Adapting Option 30 to fit the Cotswolds National Landscape

The A417 Missing Link at the Air Balloon

Outline Representation Sept 2021

Example: 1.2km Tunnel using New Austrian Method (Maps: Bing, Magic)

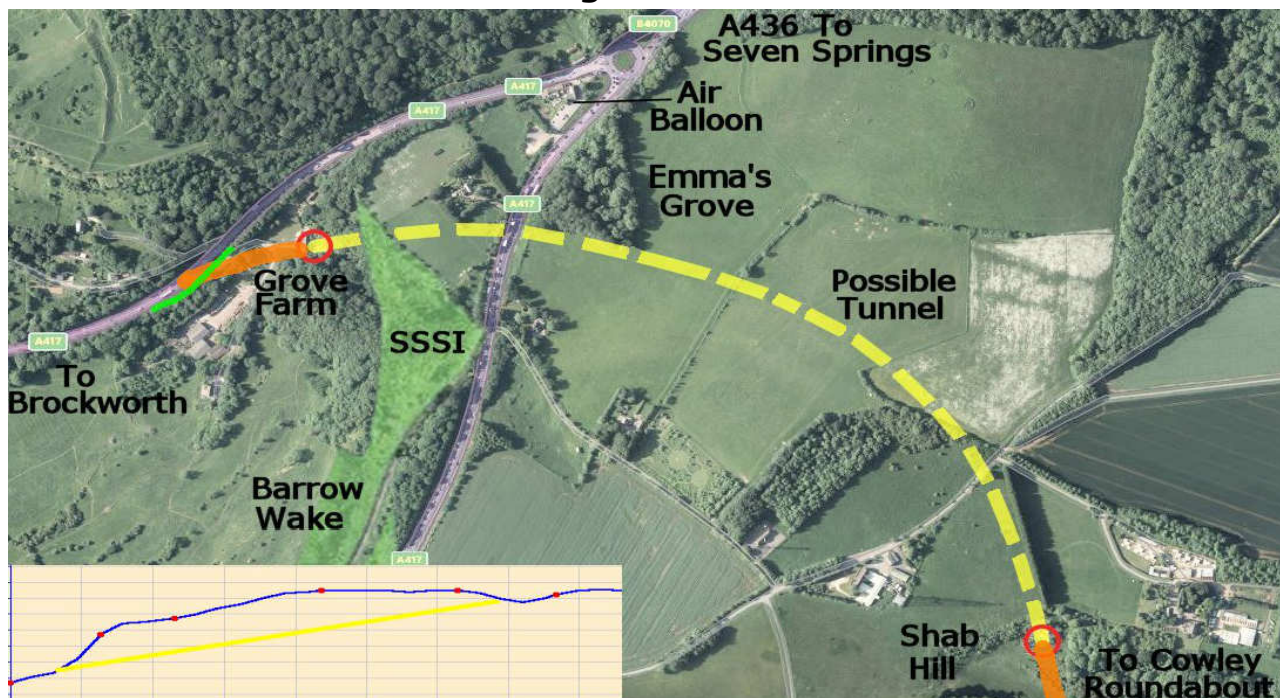
5% Gradient, under Barrow Wake SSSI, avoids Emma's Grove and the Air Balloon

After long and careful consideration of the scheme proposals, it appears that the very special environment of the Cotswolds AONB between Barrow Wake and the Air Balloon can only be properly retained if the new A417 is put into a tunnel.

Ramblers have put forward various tunnel options during the consultations. A 1.2km tunnel, in yellow above, from the scarp edge at Grove Farm to a valley face at Shab Hill, has a height gain of 60 metres i.e. a gradient of 5% - within the DMRB rules of maximum 6% for a tunnel. (Connecting roads shown orange, down slip green as per Option 3 and simplified Option 30.) The A417 gradient from Brockworth to Grove Farm is retained at 7%, less than the currently planned 8%. Option 3 proposed a 1km tunnel slightly south of the line. Option 30, to the north, could be tunnelled between Emma's Grove and the Air Balloon.
